この通知は、ザイリンクス VO48/VOG48 パッケージの出荷トレイが変更されることをお知らせするものです。

VO48/VOG48 パッケージ用の出荷トレイが Daewon 社製のトレイから Kostat 社製のものへと変更されます。

図 1 : トレイ詳細図

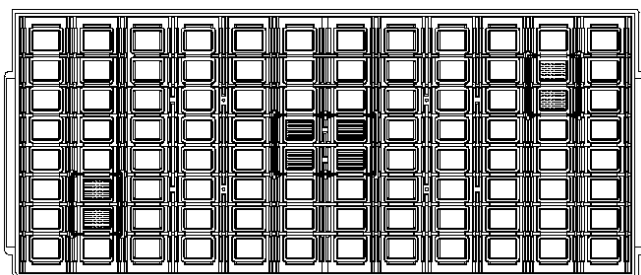
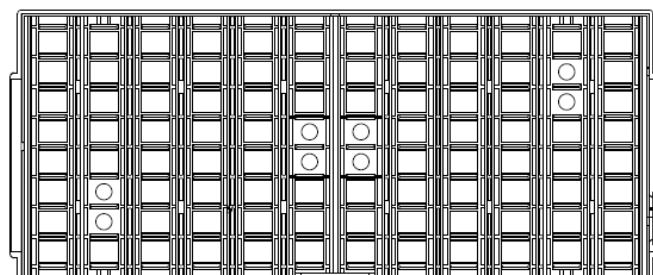
新しい Kostat 社製のトレイのマトリクスは、Daewon 社製のトレイと互換性があり、X/Y 寸法は一致します。ただし、Daewon 社製のトレイには滑り止めが付いているため、これら 2 社のトレイを積み重ねることはできません。この新しいトレイのネ스팅 ポケットは従来の 1.50mm に対して 1.91mm というより深い構成となり、コンポーネントをこれまで以上に安定して収納できるため、押し合いによる問題が軽減されます。これら 2 社のトレイを重ねたり、混ぜて使用したりしないことを推奨します。

ザイリンクスは 2012 年 9 月 9 日より、新しいトレイの使用を開始します (データ コード : 1237)。
